Docket 07-035-08
Review of Dr. Richard Drake Complaint
against Rocky Mountain Power
Final Report

Re: Docket 07-035-08

I am pleased to enclose our final report on the above-referenced Docket covering our review and analysis efforts in support of the DPU in regard to the complaint filed by Dr. Richard Drake against Rocky Mountain Power.

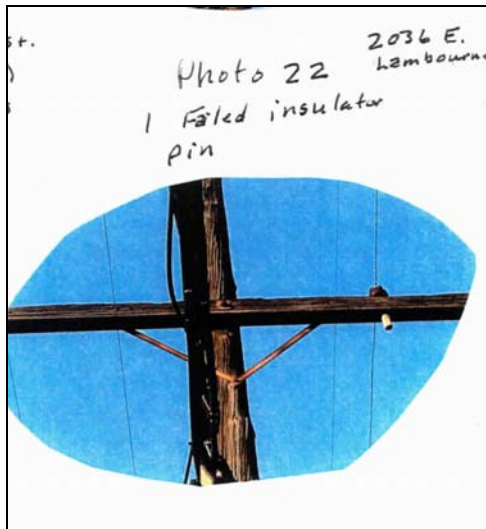
If photograph 22 provided by Dr. Drake (DR 0..3 – Lambourne Photographs), which claims "1 failed insulator pin," is the photograph described in the letter, the insulator is indeed a squatter, but the angle of the pin and the insulator clearly shows that the pin/insulator interface is intact. The entire pin is tilted likely due to elongation and wear in the drilled hole in the crossarm. This does not indicate a "floater" since the insulator is still held securely. A copy of the subject photo follows:

Source: Outage data: RMP, Pollution data: Utah EPA

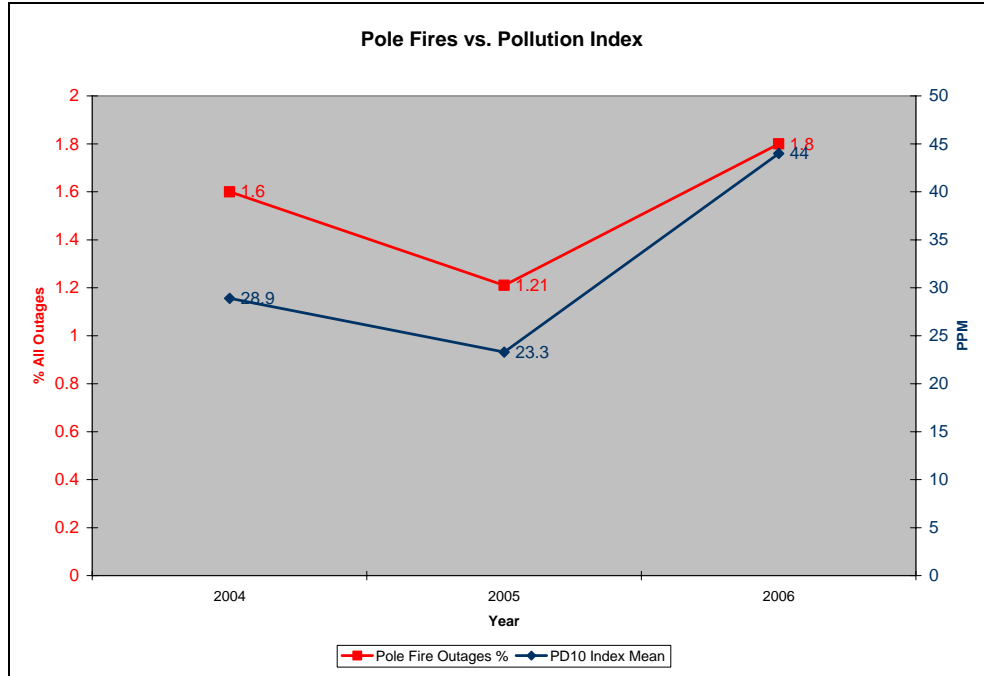
While the number of pole fires has indeed increased from 2004 to 2006, it should be noted that pole fires decreased significantly in 2005. This is consistent with RMP's statement that many of the recent pole fires are the result of high pollution levels coupled with light misting rain, which can produce a condition on the insulators that promotes tracking¹. It is interesting also to note that the percentage of pole fire outages in SLC metro (at about 27%) is consistent with its share of customers (at also about 27%).

Utah EPA statistics clearly show a similar trend in particulates below 10 micrometers (PD10) in size (combustion - motor vehicles, power plants, wood burning, etc., some industrial processes, crushing or grinding operations, and dust from paved or unpaved roads). As shown in the chart below, there appears to be a strong correlation between the pollution index and pole fire incidence. However, without a specific analysis that tracks each pole fire incident with atmospheric pollution and precipitation surrounding the date and time of the outage, it is not possible to draw conclusive findings. Nonetheless, the pattern of pollution and pole fires is consistent and supports RMP's conclusion as to the cause of some pole fires.

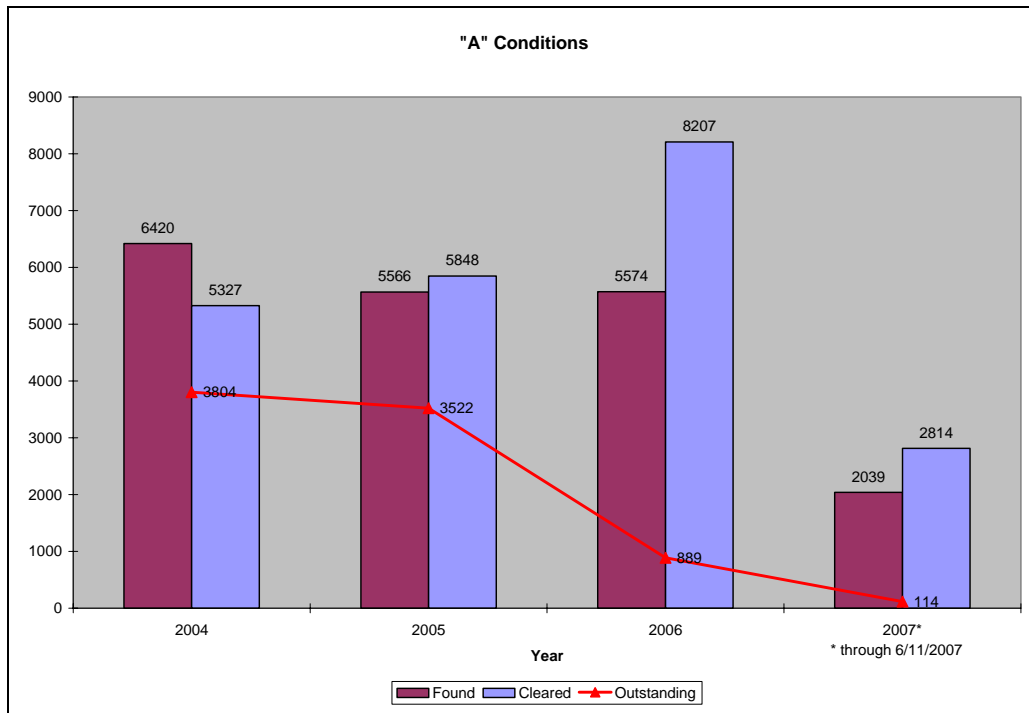
RMP has put substantial effort into correcting "A" conditions found as a result of its inspections, outage responses and other reporting means. "A" conditions have been reduced from 3,804 in 2004 to less than 114 through 6/11/2007 in 2007, as depicted on the following chart.
